AMENITY CONCEPT PLAN

THE OAKS PRESERVE
 MANSFIELD, JOHNSON COUNTY, TEXAS

08-02-17

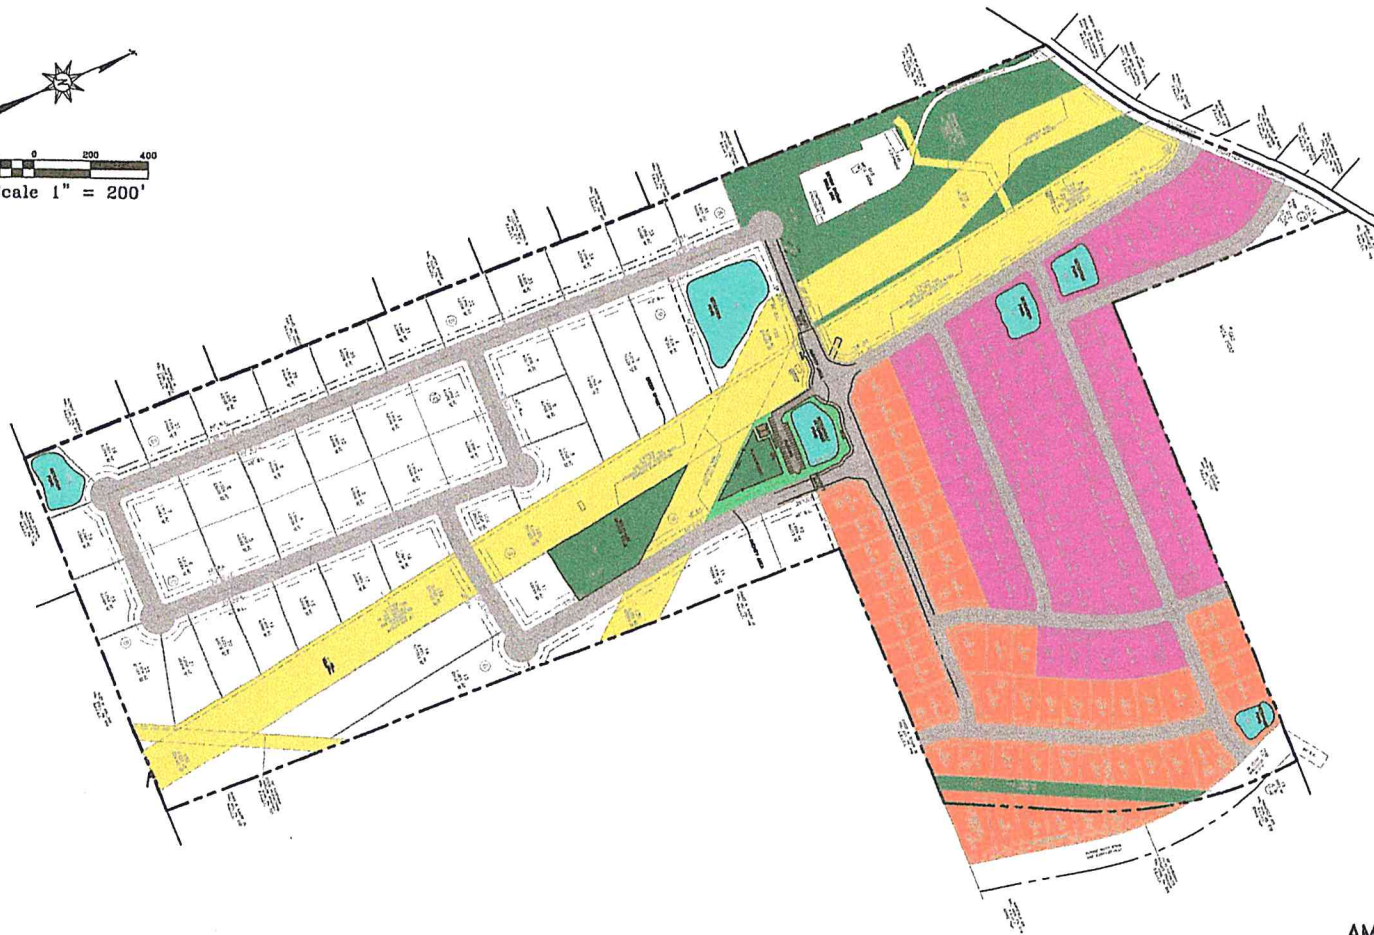
- ***This revision places the amenity and activity space in the center of the community. There were ongoing storm drain concerns regarding the activity and amenity area since they were placed in the lowest corner of the property wedged between the Oncor and TRWD easements. Consequently we worked with staff to locate in an area that incorporates retention detention pond into the Amenity area.***

- The new submission has not changed this amenity. This is located in the wedge of land that is in neither easement.
- ***This revision has relocated the area dedicated to amenity per the attached Preliminary Plat and Amenity Plan. The components of the amenity have not changed.***

In summary the relocation of the amenity was necessitated by a concern over the functionality of the area dedicated as Amenity Center and Activity space.

This revision greatly increases the functionality by avoiding drainage issues. Incorporating the easements as mowed green space and creating long vistas of open space. The access to all residents is increased by locating it centrally in the community. All residents will access through the main park entrance located outside the private gated lots. The 1 acre plus lots will still be secured from all vehicular traffic by the gates and the access to the private area will remain pedestrian so that all residents can use the easement green space.
